APPLICATION FOR CONSTRUCTION OF PAVED SIDEWALK/ DRIVEWAY

RE: TB-20-936

Farland Circle (SW.S.) S. x Phillips Rd. (a/k/a Builder's Lot 21)

Reviewed 6/18/2020

--- FARLAND CIRCLE --- ASSESSORS MAP 130D LOT 488 NEW BEDFORD, MASSACHUSETTS

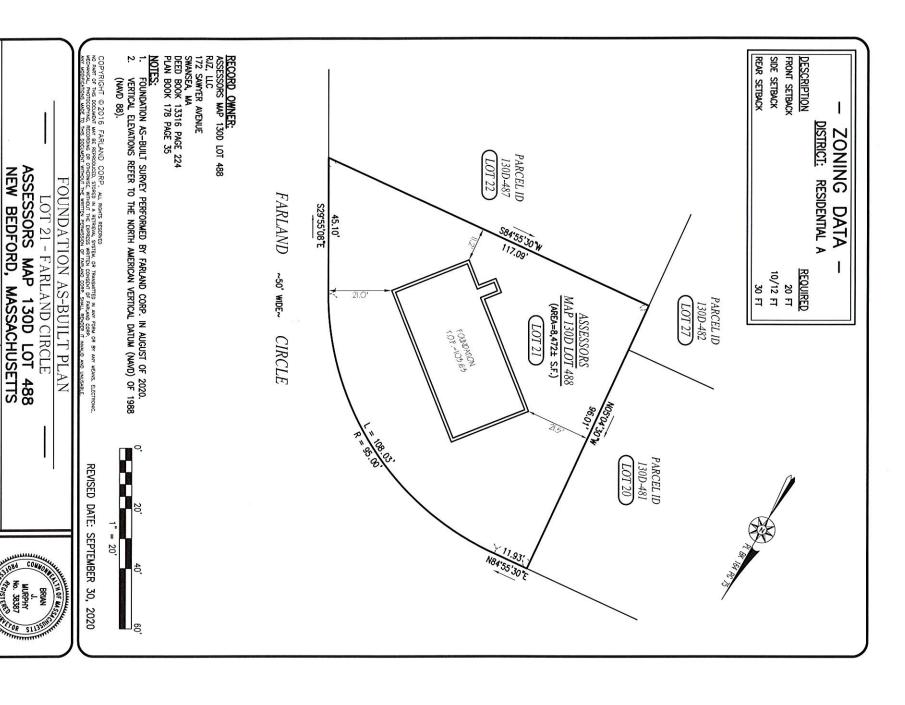
- regarding sump pump installations will apply, as follows: calculations must incorporate sump pump discharge, and the conditions stipulated by the City Engineer The plan indicates that there may be a sump pump tie-in at this location. The recharge system

- are needed before DPI signs off on the CO. stamped and signed by the same engineer documenting the design and standards. These documents engineer in the Commonwealth of Massachusetts along with the supporting calculations and plans The sump pump tie in will require a letter stamped and signed by a registered professional

- contaminated the groundwater and site. This needs to be inspected and signed off by our inspector a spill in the basement, it cannot flow into the pit and be pumped to the infiltrator unit thereby prior to signing of the CO A concrete lip should be constructed around the sump pump and pit (6-in high) so that if there

4. IF SUMP PUMP IS INSTALLED, A CONCRETE LIP MUST BE INSTALLED AROUND THE SUMP PUMP. NOIES.
